Re: Canterbury Track POADP # 658

The City Staff Development Review Committee has reviewed Canterbury Tract Preliminary Overall Area Development Plan # 658. Please find enclosed a signed copy for your files. Although your plan was accepted, please note the following:

**P.O.A.D.P.
 for
 CANTERBURY TRACT**

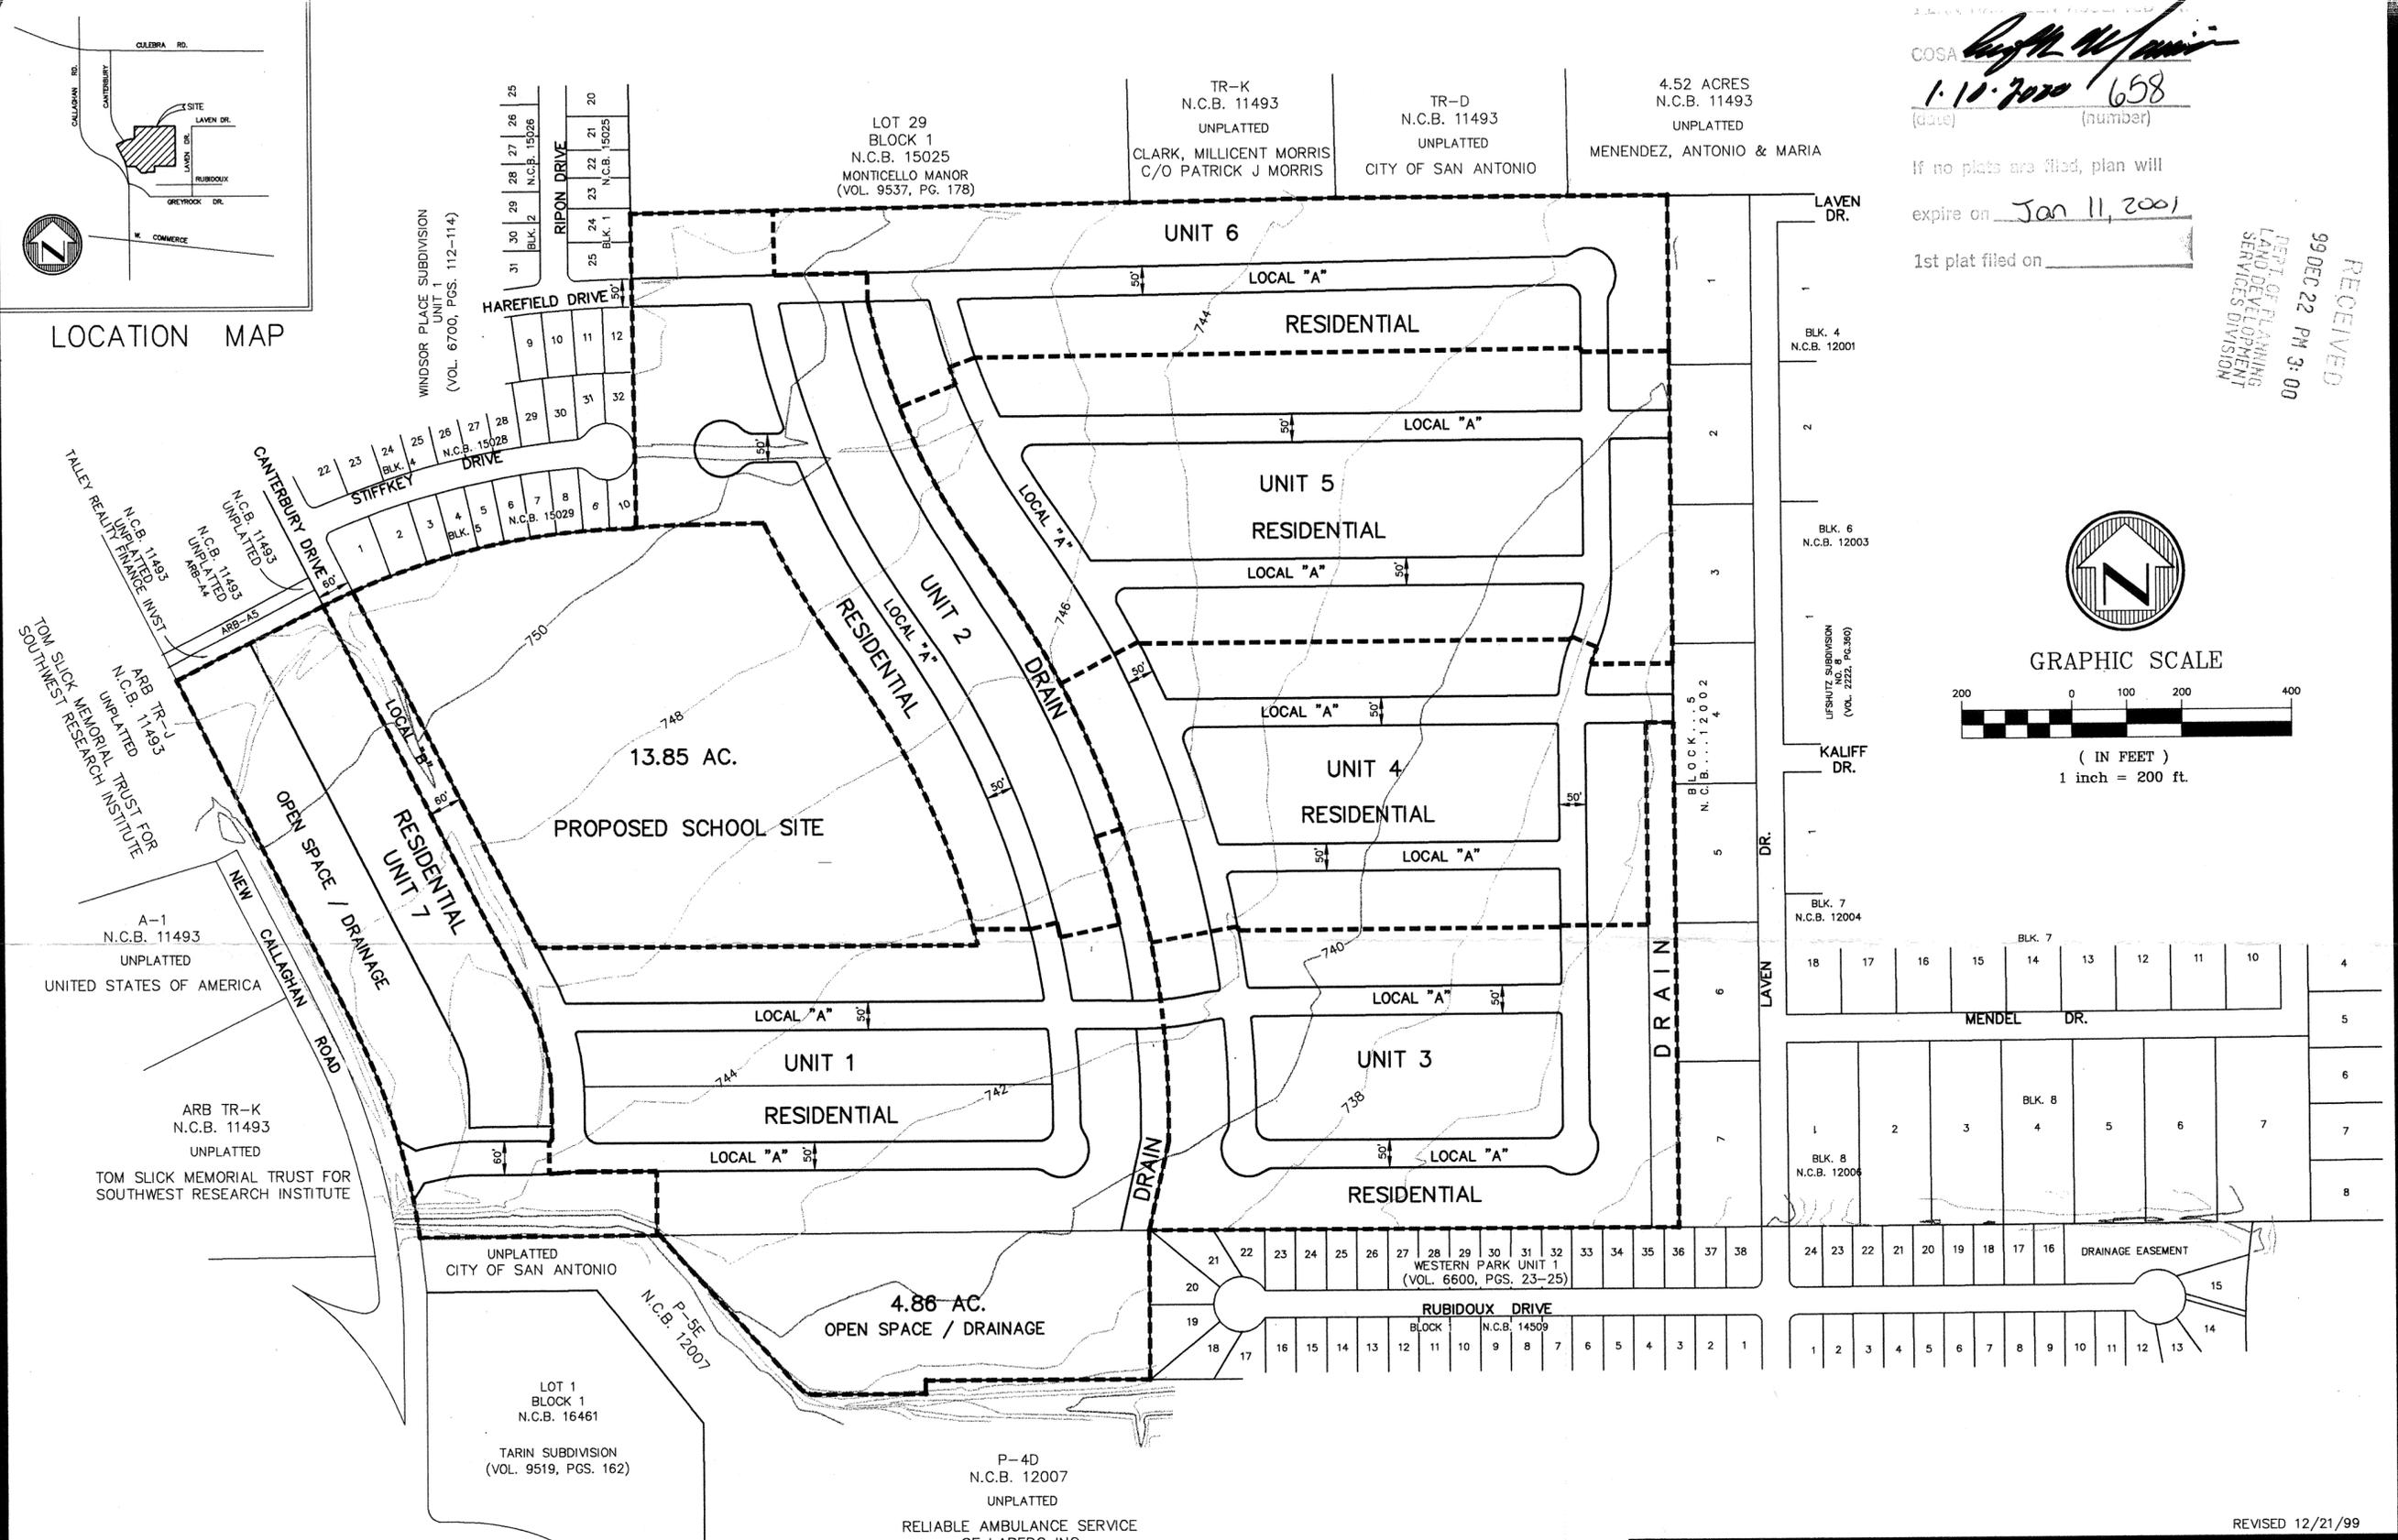
- Access to New Callaghan will require pavement improvements in addition to the installation of reflective pavement buttons and markings for Canterbury access to Culebra.

- A minor TIA revision will be required due to the additional access provided at New Callaghan. Make arrangements with Public Works regarding the revision prior to plat approval.

- Based on the topography, a Flood Plain Study and drainage review will probably be required during the platting process.
- In consideration of public safety and convenience, excessive grades by reason of topography should be avoided in street layouts and arrangements.

- This development will need to comply with tree preservation ordinance #85262. For information about these requirements you can contact Building Inspections at 207-7102.

- It will be expected that you will plat all of the property depicted in your POADP, to include: floodpains, drainage areas and open space.
- I would encourage you to work closely with the school district, so that they can plan accordingly.
